# Access Compliance Report

## Public Rights-of-Way

### (Curb Ramps)

Intersection ID: 31188	Main Street: BARBEE_DR	Cross Street: CARVER_POND_RD	Location: NE
ADA ID: D28F23ED2710	Ramp Type: BlendTrans1	Initial Pass/Fail: Fail	Overall Compliance: No
Codes/Mitigation Info/Possible Solution			Severity Score: 10
			Field Measurements/Component Compliance

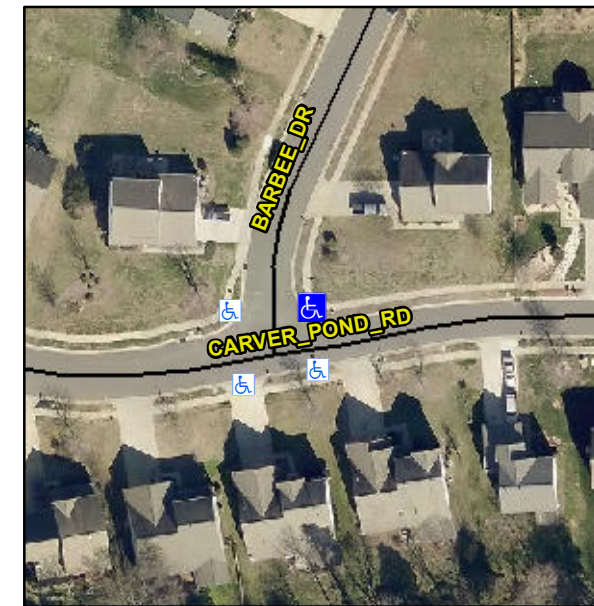
**Not Found, R304.5.1, R304.5.3**

Compliance	Description	Data	Compliance	Description	Data
N/A	Ramp Length (in)	49.0	Yes	BlendTrans Slope (%)	1.9
No	Ramp Width (in)	38.0	No	BlendTrans XSlope (%)	4.3
N/A	Flare Type LT	N/A	N/A	Flare Type RT	N/A
N/A	Flare Slope LT (%)	N/A	N/A	Flare Slope RT (%)	N/A
N/A	Flare Traversable LT?	N/A	N/A	Flare Traversable RT?	N/A
N/A	Landing Length (in)	N/A	N/A	DWS Provided?	N/A
N/A	Landing Width (in)	N/A	N/A	DWS Contrast?	N/A
N/A	Landing Slope (%)	N/A	N/A	DWS Length (in)	N/A
N/A	Landing X Slope (%)	N/A	N/A	DWS Full Width?	N/A
N/A	Landing Curb? (Y/N)	N/A	N/A	DWS Offset (in)	N/A
N/A	Shared Landing?	N/A			
N/A	Gutter Ponding?	N/A	N/A	Gutter Slope (%)	N/A
N/A	Gutter Lip Ht (in)	N/A	N/A	Gutter X Slope (%)	N/A
N/A	Painted X Walk1?	No	N/A	Painted X Walk2?	No
	X Walk 1 Direction	To W		X Walk 2 Direction	To S
	X Walk 1 Width (in)	N/A		X Walk 2 Width (in)	N/A
	X Walk 1 Slope (%)	2.9		X Walk 2 Slope (%)	2.3
	X Walk 1 X Slope (%)	4.1		X Walk 2 X Slope (%)	4.1

N/A	Ramp inside XWalk1?	N/A	N/A	Ramp inside XWalk2?	N/A
	Road Slope (%)	4.1		Clear Space?	N/A
	Road X Slope (%)	1.9	N/A	Clear Space to XWalk (in)	N/A
N/A	Any Obstructions?	N/A	N/A	Storm Grate/Utility Hazard?	N/A
	Obstruction Type			Storm Grate/Utility Type	
		N/A			N/A
			Yes	Surface Condition? (G/P)	Good
			No	Curb Slope (%)	6.0

**Remove & Replace Curb Ramp With Two New Directional Ramps or Equivalent.**
